工程指示 / 要求簡箋(E.I.)

工程指示編號：EI / 2569 / 20

工程名稱：亞皆老街中電

工程項目：鋁飾線 模圖批核 (3 個) X85922-X85924

X85922

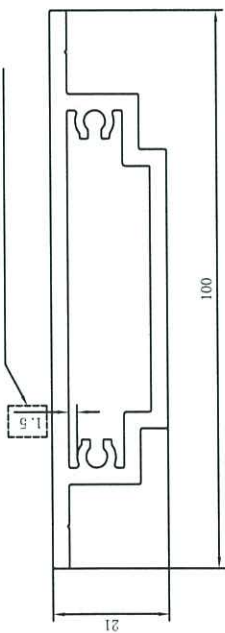
此处尺寸过窄，无法成型，建议修改

建议修改如右图所示
